IRRIGATION PLAN
Taco Time
Azure Green Consulting Engineers
1115 E. Main Ave., Puyallup, WA

LANDSCAPE PLAN
Taco Time
Azure Green Consulting Engineers
1115 E. Main Ave., Puyallup, WA

Scale: 1"= 20'0"
Designer: MFW
Project Manager: MFW
Principal: KBR
Date: 28 JULY 2023
Phase: CITY SUBMITTAL #1
Project No.: 20017
Sheet No.: L-1 of 2 Sheets
1:1

Landscape Plan

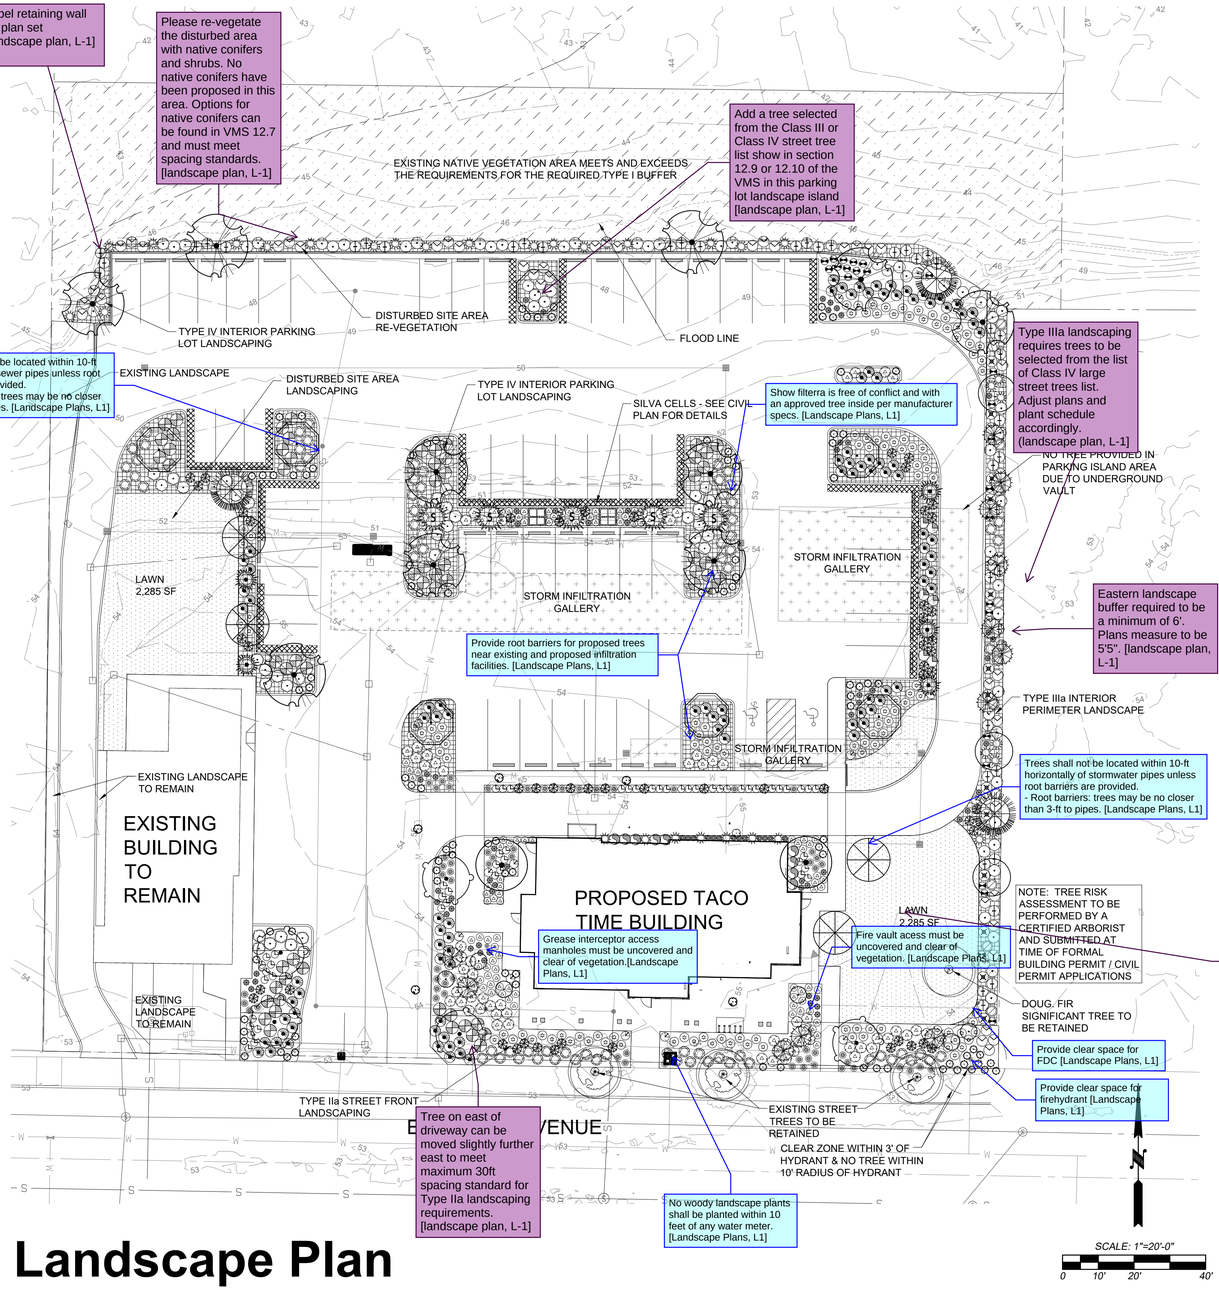
Plant schedule should propose trees from VMS Chapter 12. Please remove tree types that are not listed and replace with allowed tree types. Please note that Type III perimeter landscaping require trees to be selected from VMS 12.10 Class IV - Large Street Trees.

Coniferous evergreen trees shall be a minimum of 5-6ft in height per VMS 7.2(f)

The landscape types (Type I, Type II, etc.) require specific on-center spacing to be met. Please meet on-center spacing standards. [landscape plan, L-1]

Verify that the total estimated topsoil required is for the 8-inch minimum soil standard for all landscaped areas. Your contractor will be required to submit delivery sheets and demonstrate compliance with top soil required and specified on plans at the time of final inspection. [landscape plan, L-1]

Any required trees that are proposed too close to utility lines and are unable to be moved to meet the 10ft spacing requirement from utilities shall be moved to this lawn area if possible. Use root barriers per engineerings direction if necessary. [landscape plan, L-1]
